CHANGE BULLETIN 06

F.G.A. No. 21003

ROOMS TO GO – OFFICE RENOVATION & EXPANSION

June 12, 2023

SHEET NUMBER
M1.10A

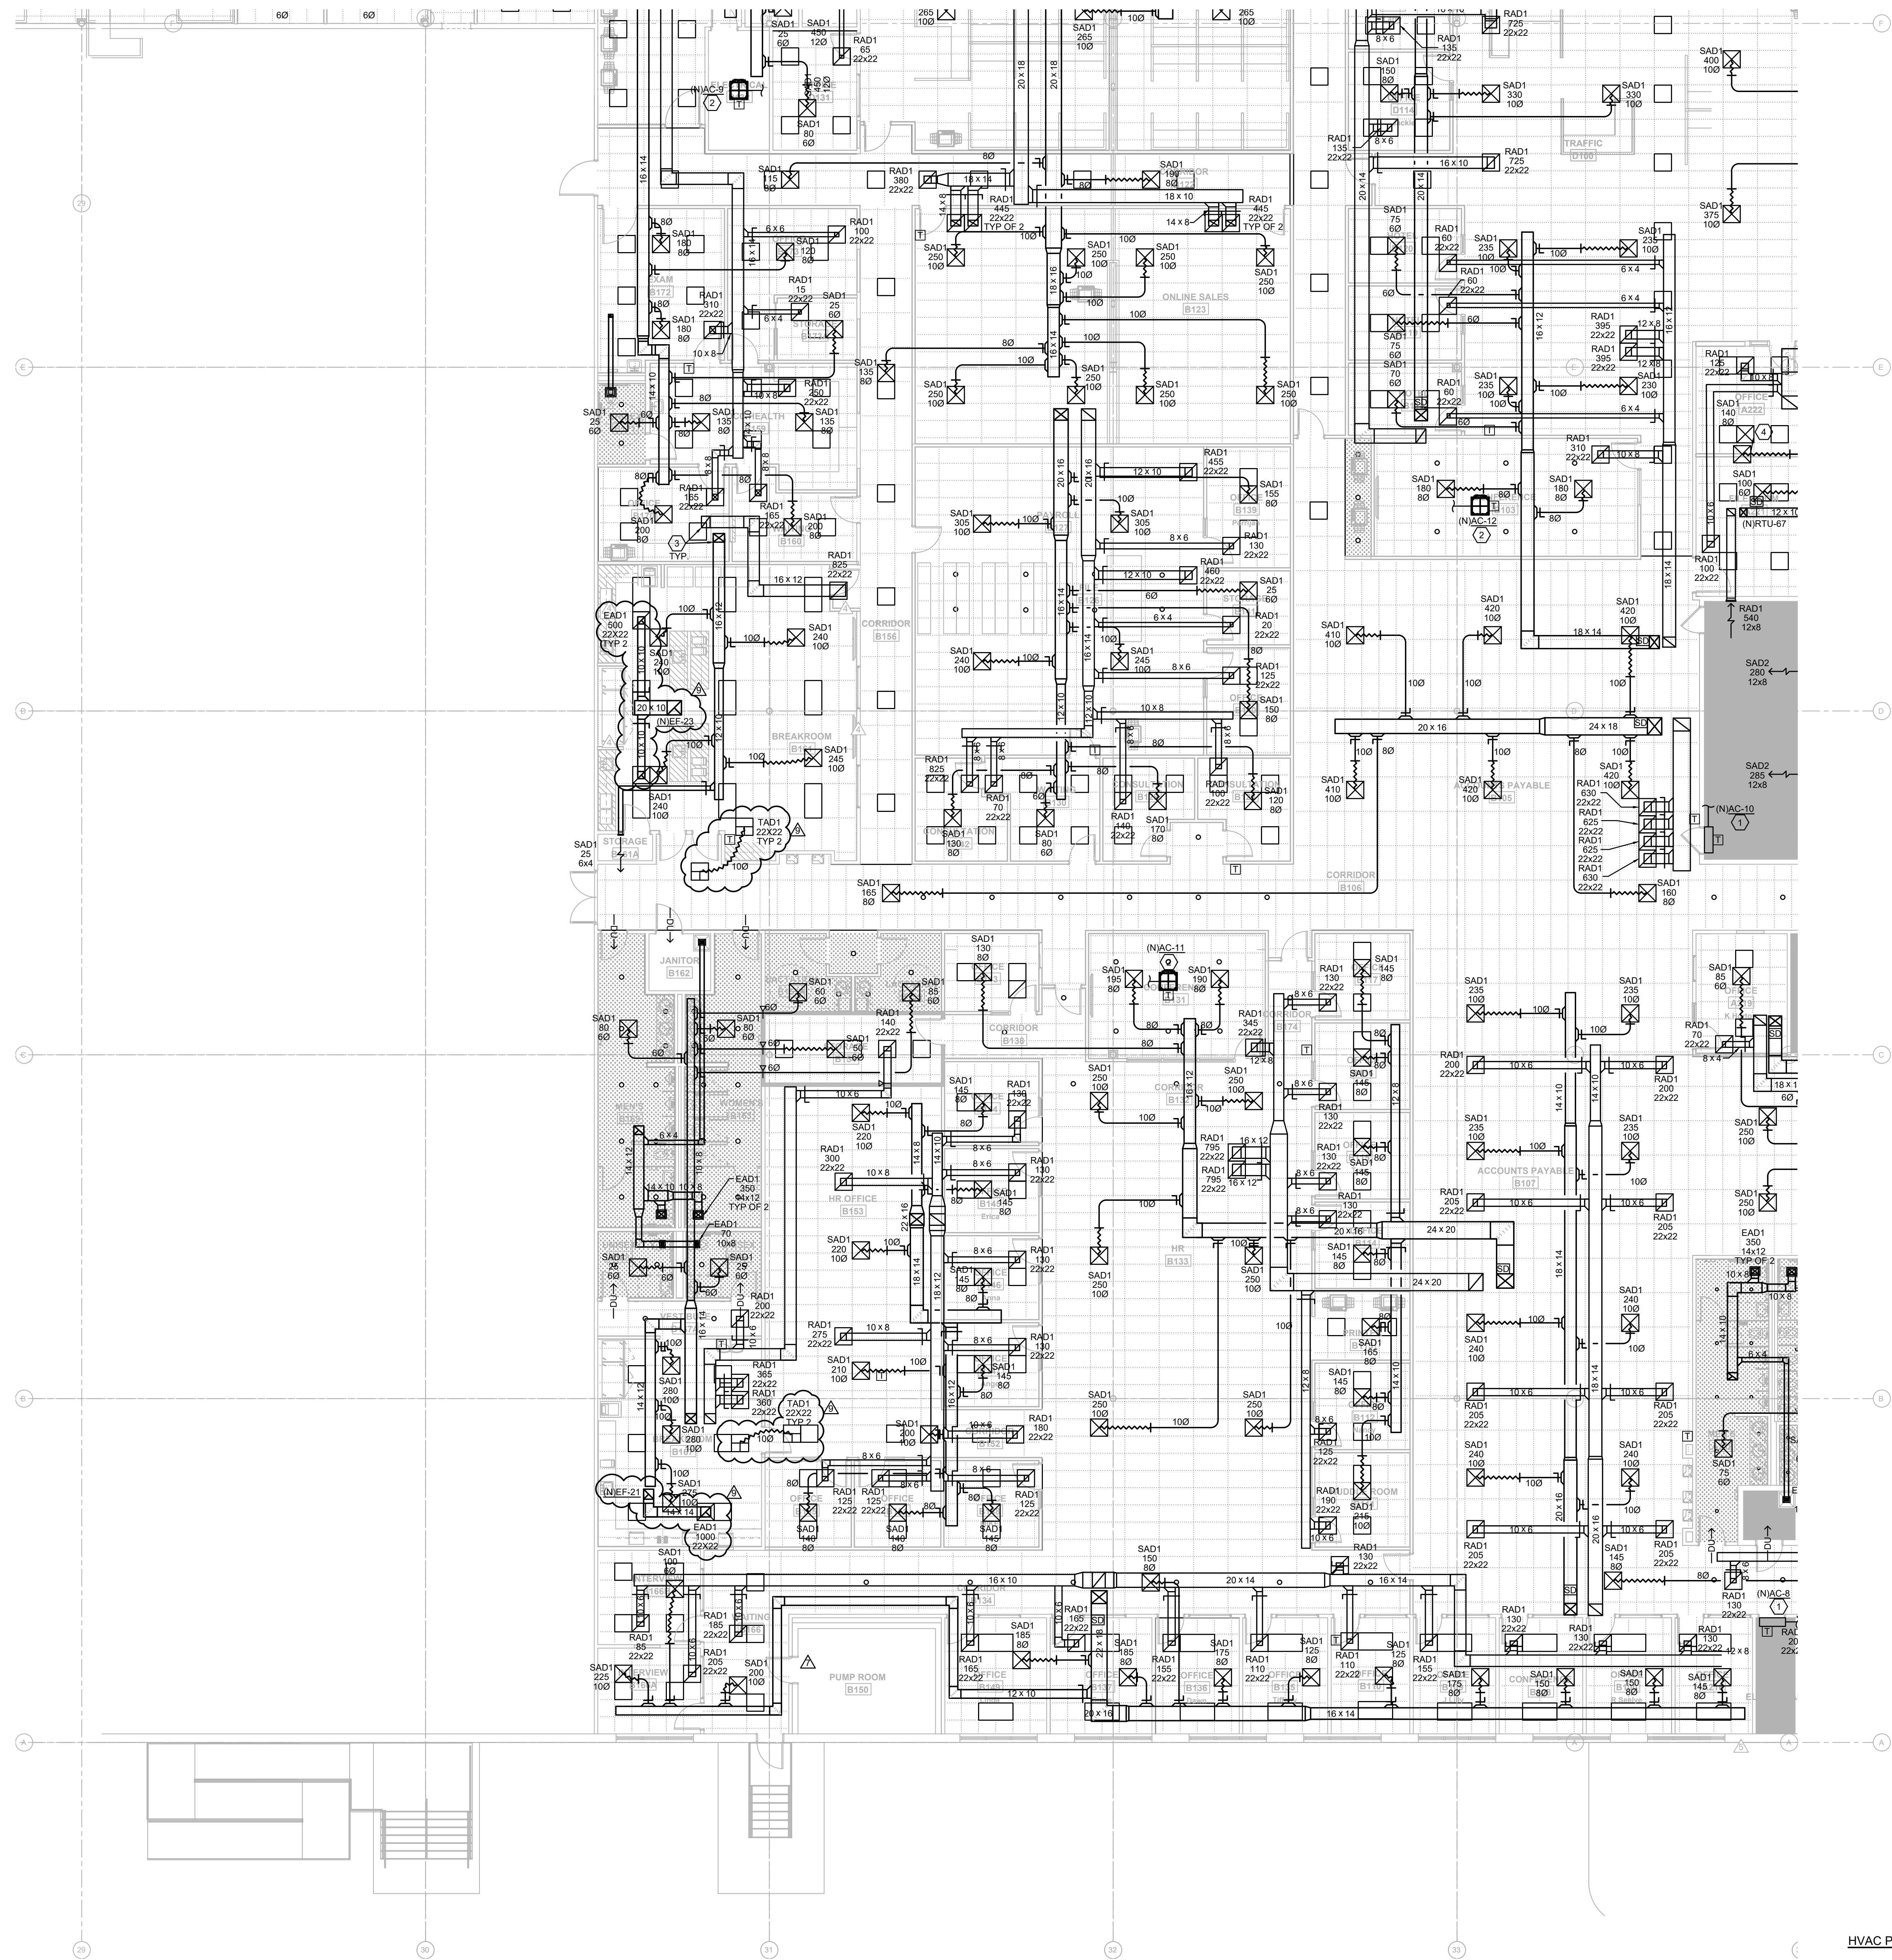
- Item 5: Refer to Sheet M1.10A - HVAC Plan – A
- Add roof mounted exhaust fans (N)EF-15 through (N)EF-23 and associated exhaust ductwork and grilles to all the breakrooms and pantries.

SHEET NUMBER
 M1.10B

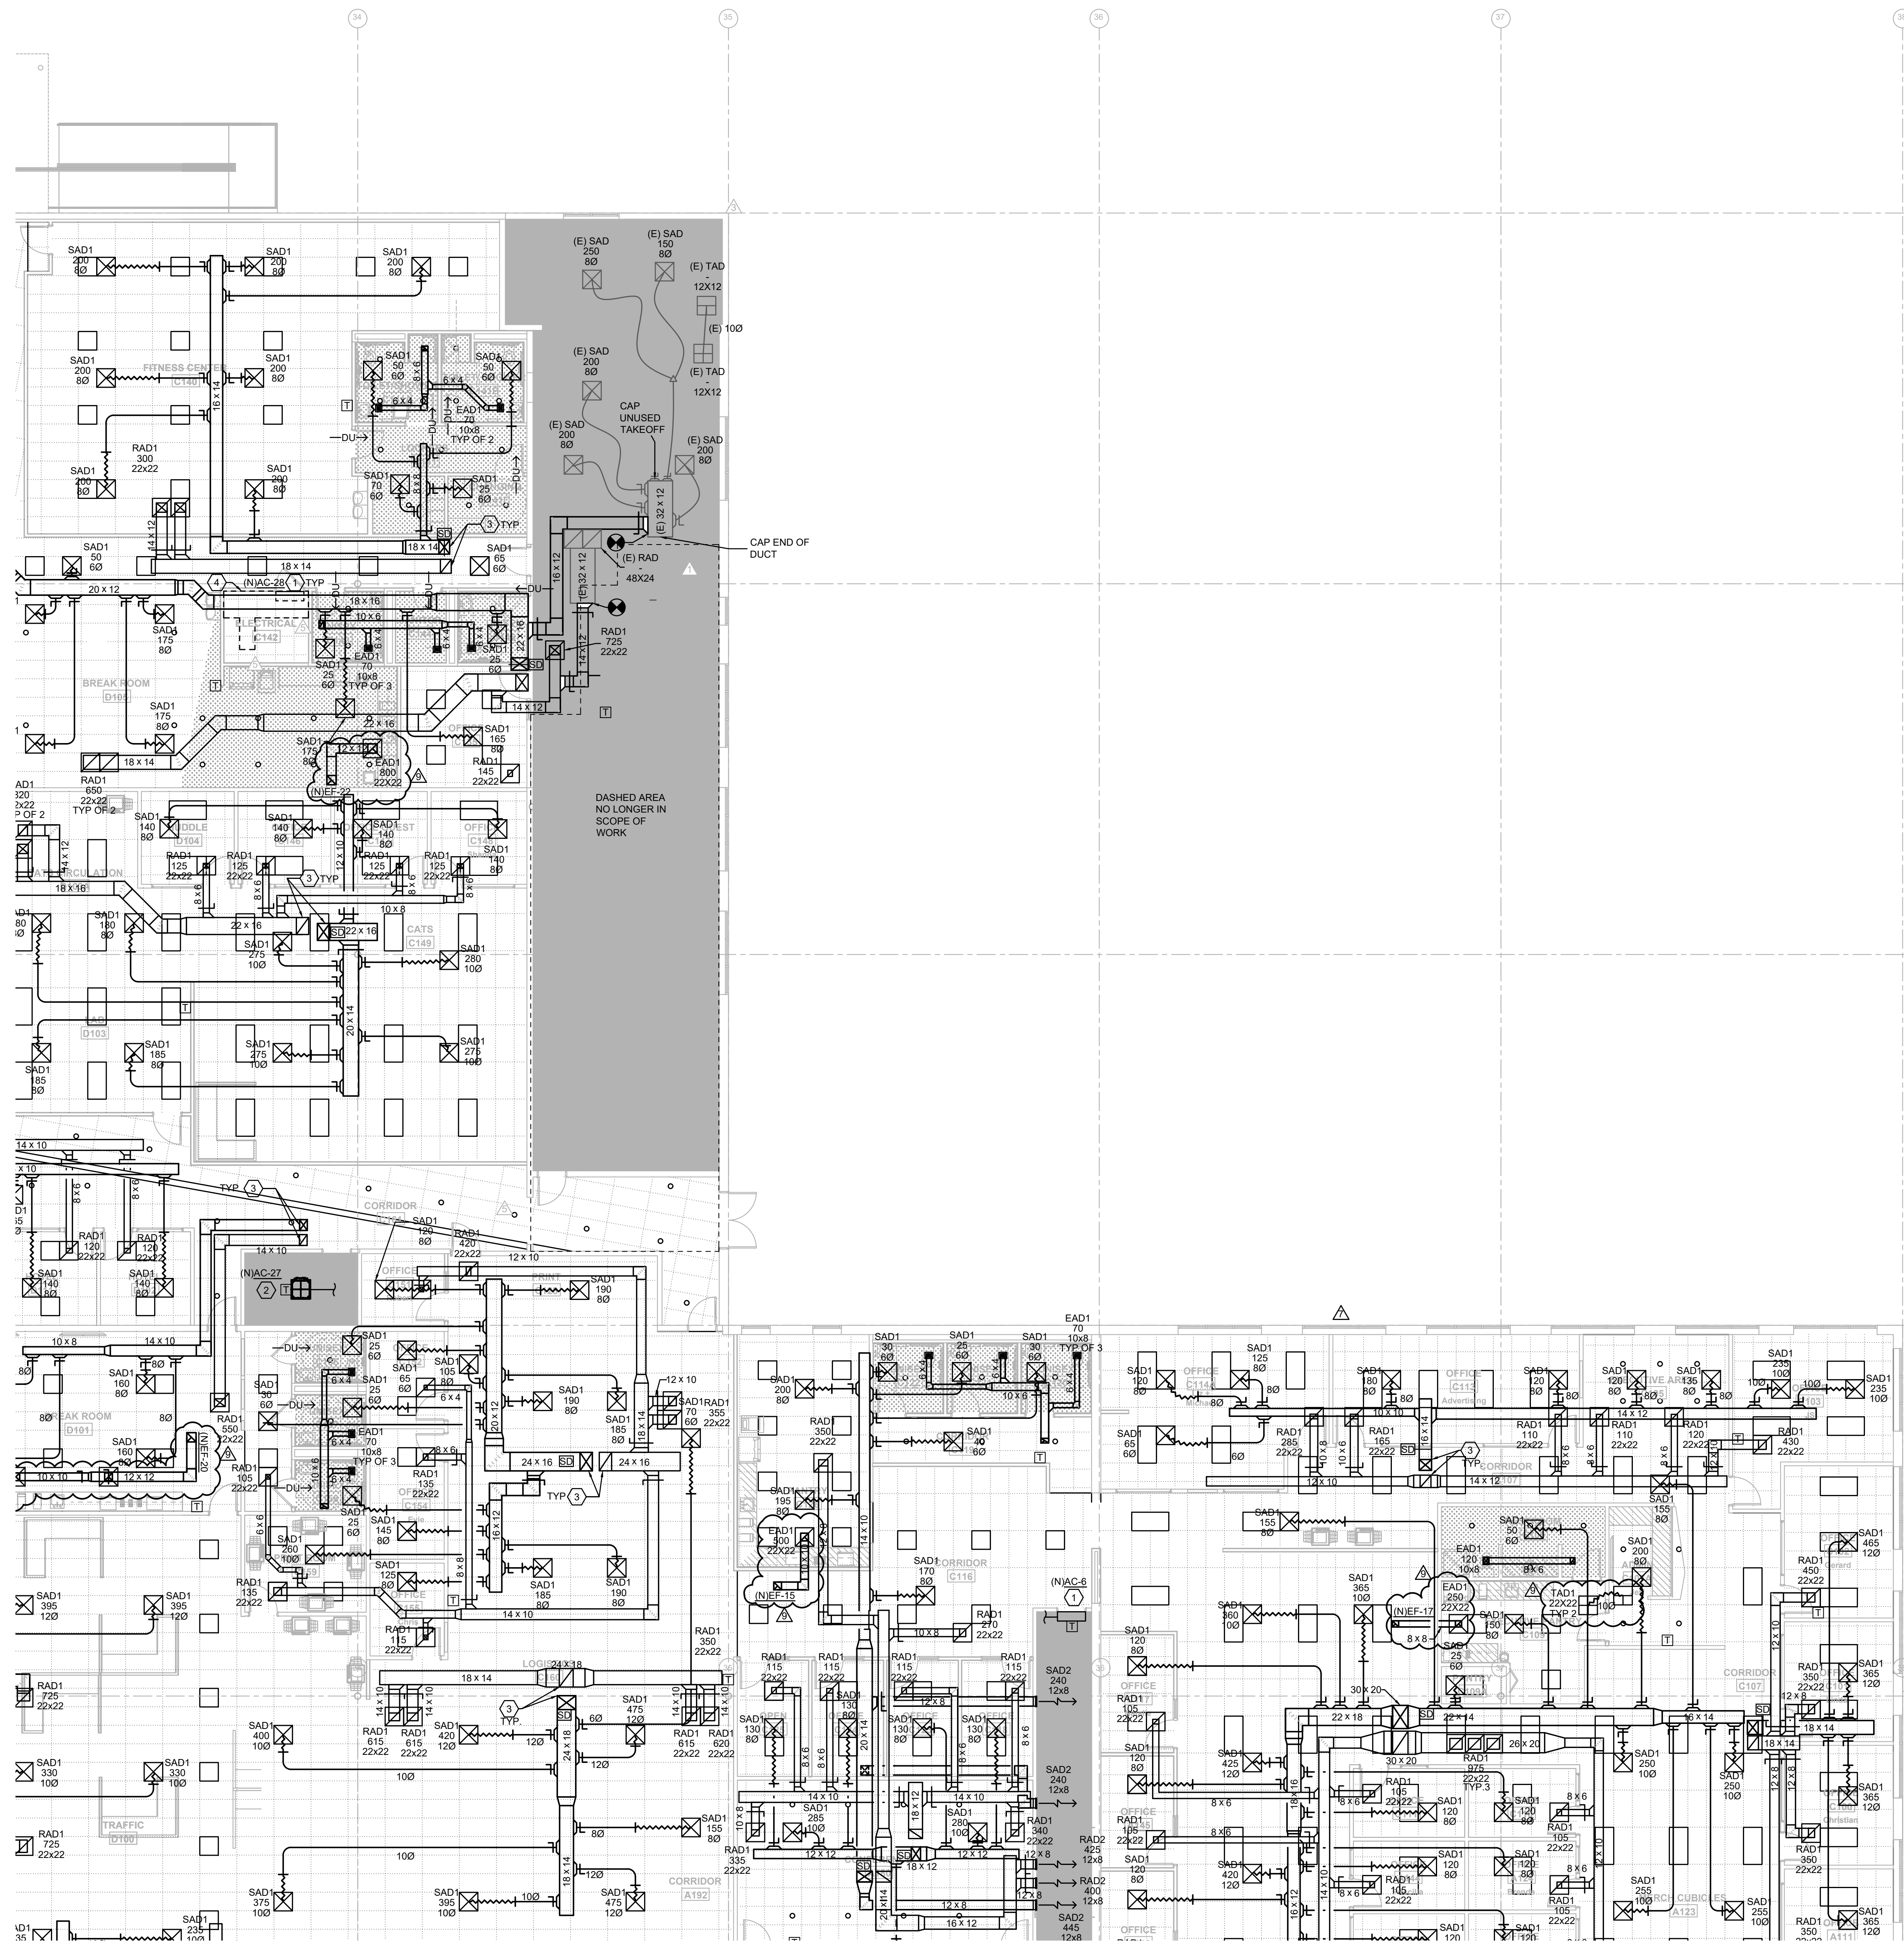
- Item 6: Refer to Sheet M1.10B - HVAC Plan – B
- Add roof mounted exhaust fans (N)EF-15 through (N)EF-23 and associated exhaust ductwork and grilles to all the breakrooms and pantries.

SHEET NUMBER
M1.10C

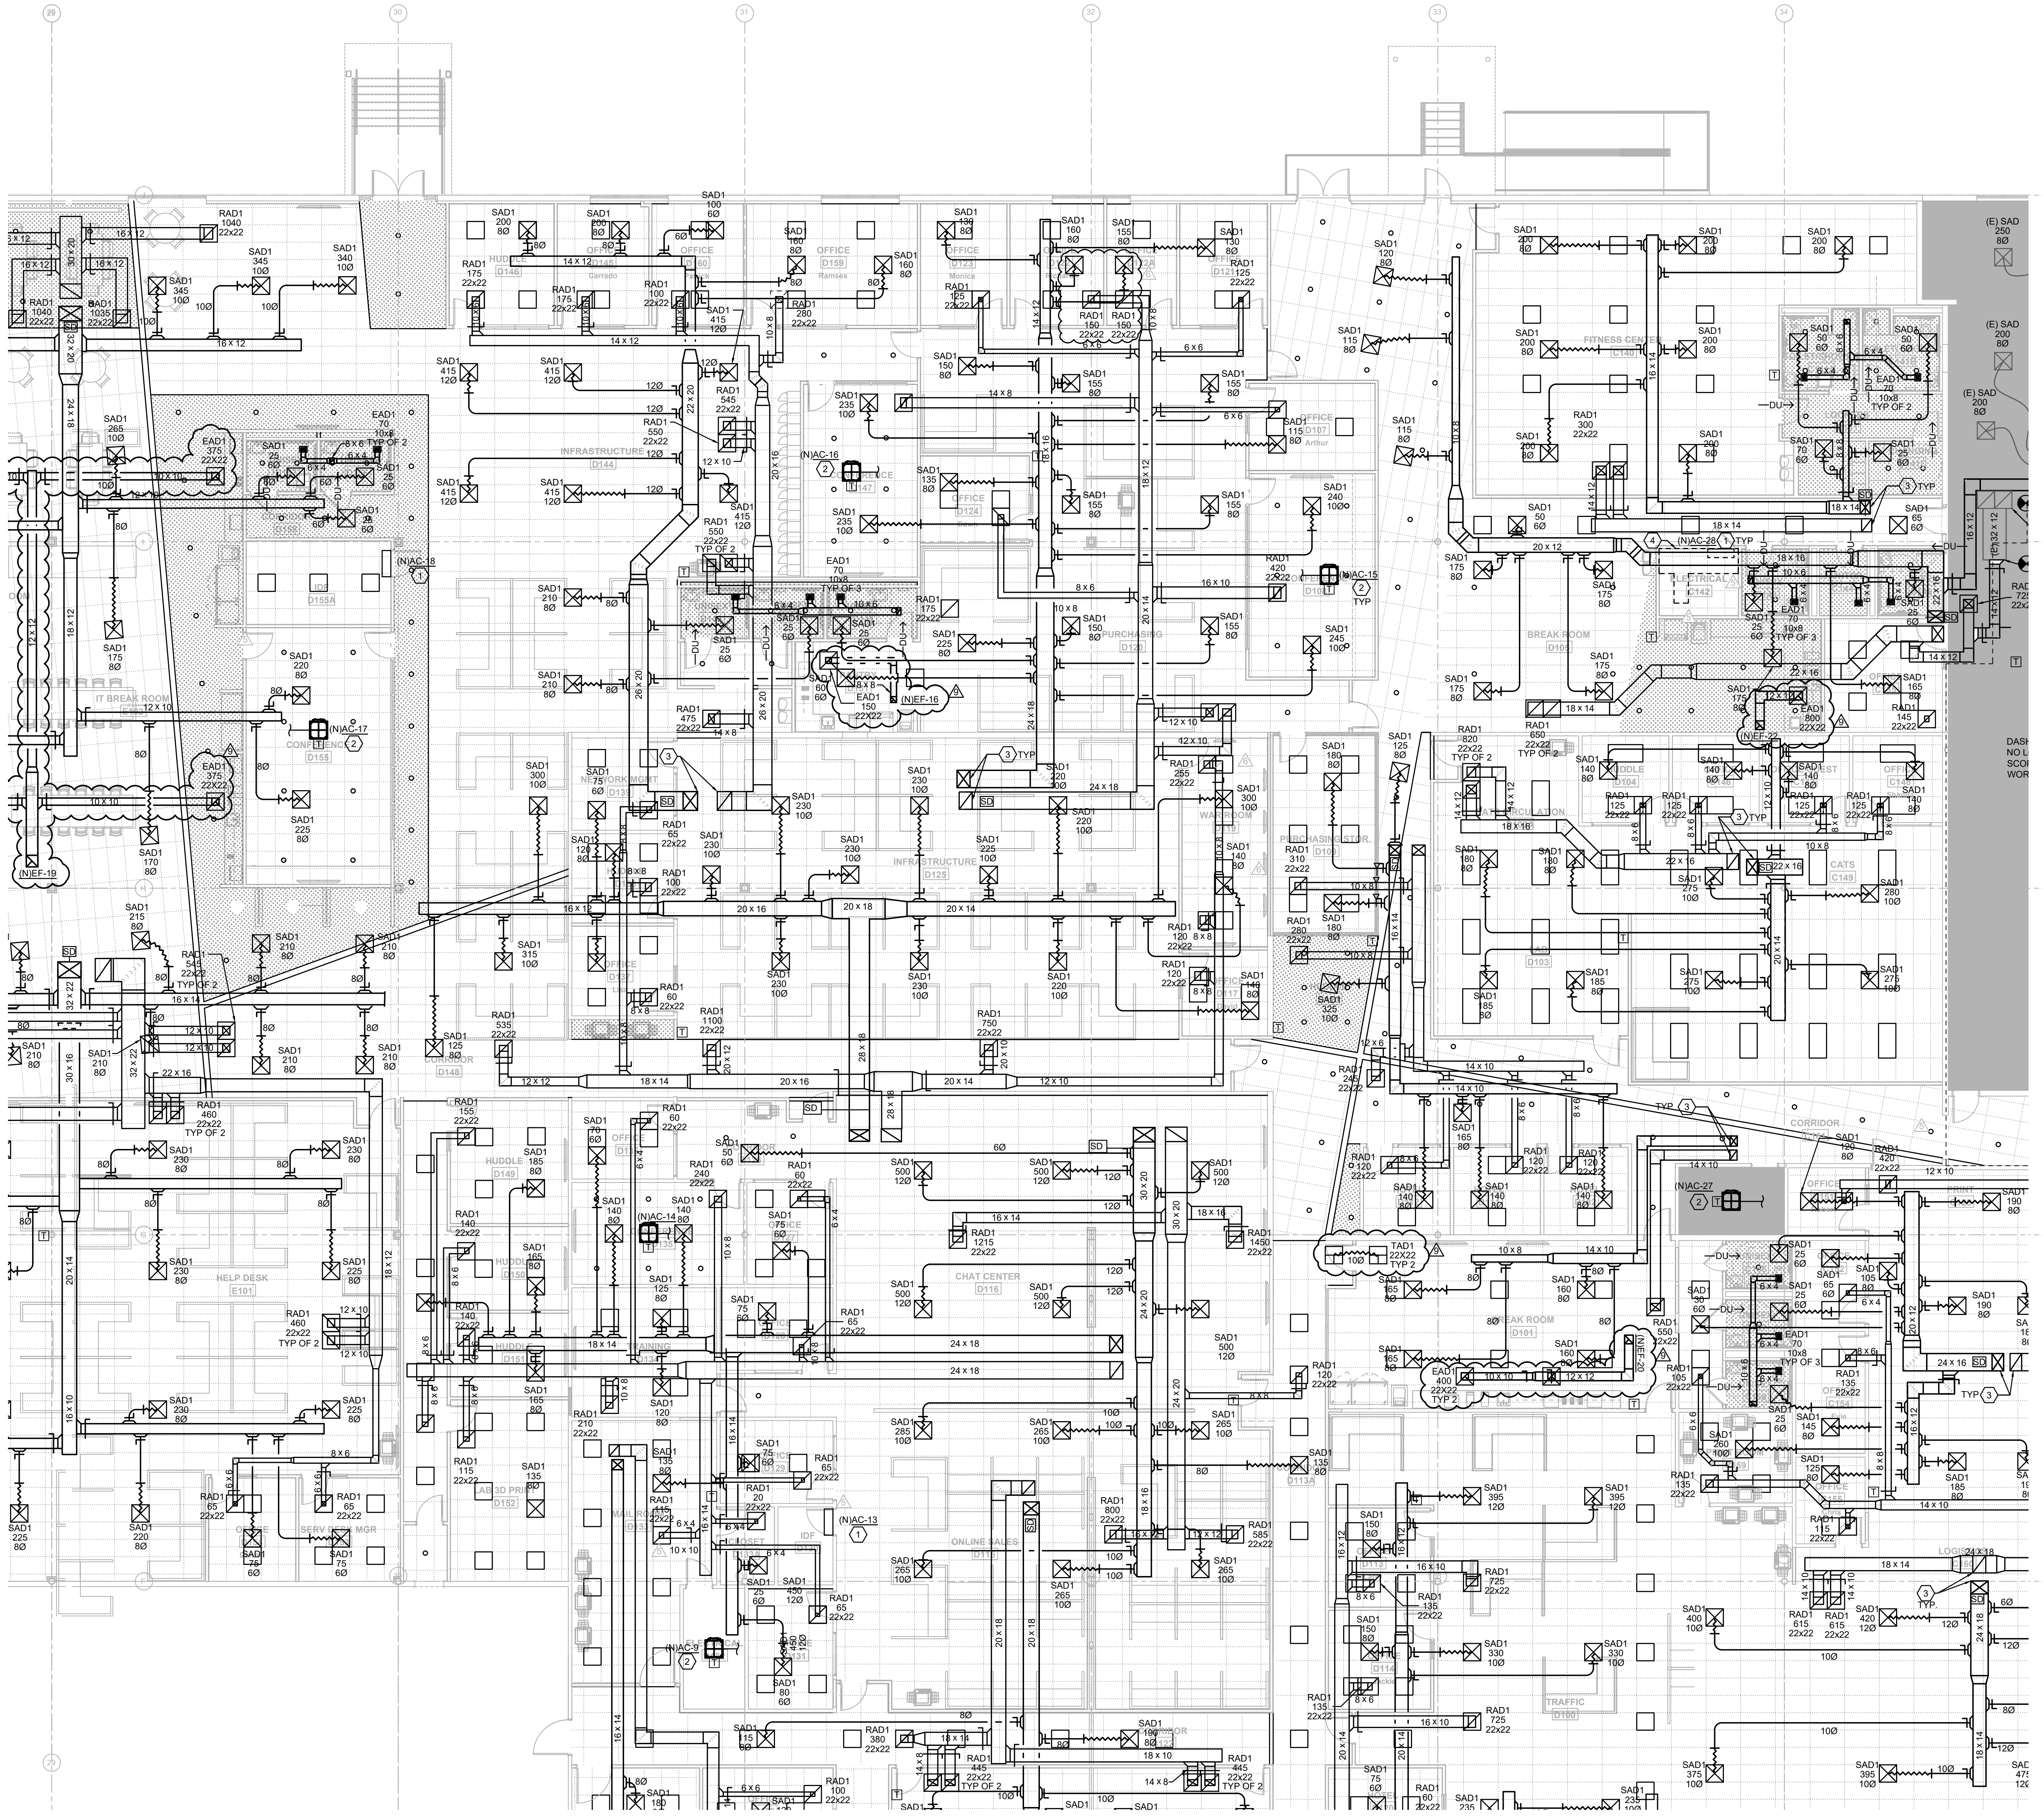
- Item 7: Refer to Sheet M1.10C - HVAC Plan – C
- Add roof mounted exhaust fans (N)EF-15 through (N)EF-23 and associated exhaust ductwork and grilles to all the breakrooms and pantries.
